Planning Commission Meeting Agenda

Tuesday, March 20, 2018, 5:30 PM

1. Searle Residence Landmarking and Addition (CK), PL-2017-0070, 300 E. Washington Street 8

1. Brenner Materials Concrete Batch Plant (CK), PL-2018-0056, 13545 Colorado State Hwy 9 34

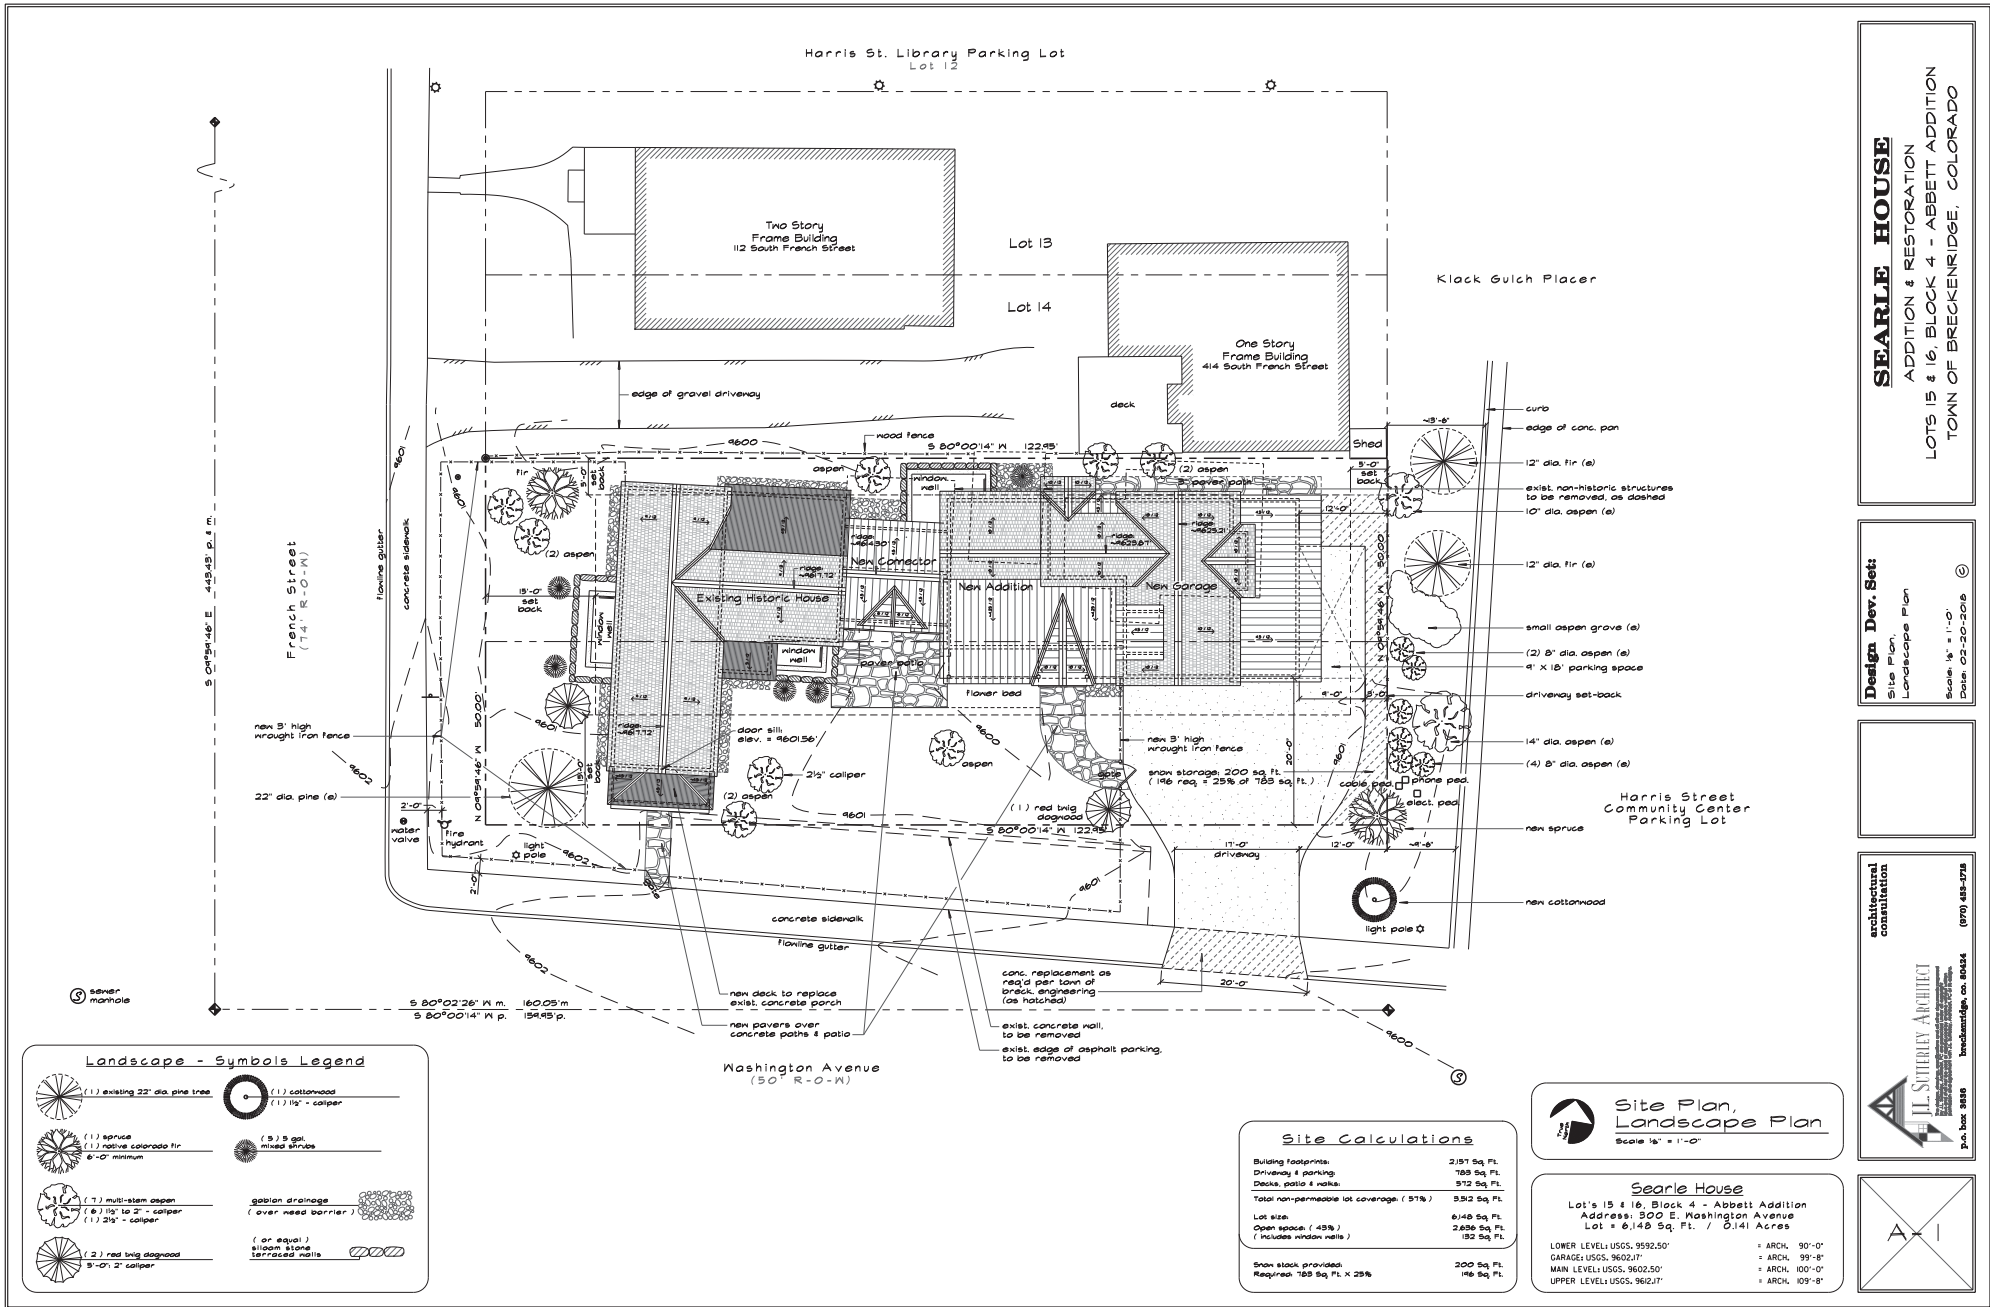
At the previous meeting staff and the Commission believed this was a nice landscape design and appreciated the cottonwood tree that was added along Washington Avenue. Staff believes a second cottonwood tree should be added along French Street to better comply with Design Standard 172. If the Commission concurs, the project is still approvable with the added condition requiring the installation of one additional cottonwood tree along the French Street side of the property prior to a Certificate of Occupancy.

- 3. Applicant shall add one additional Cottonwood tree along the French Street side of the property.**
4. Applicant shall revegetate all disturbed areas with a minimum of 2 inches topsoil, seed and mulch.
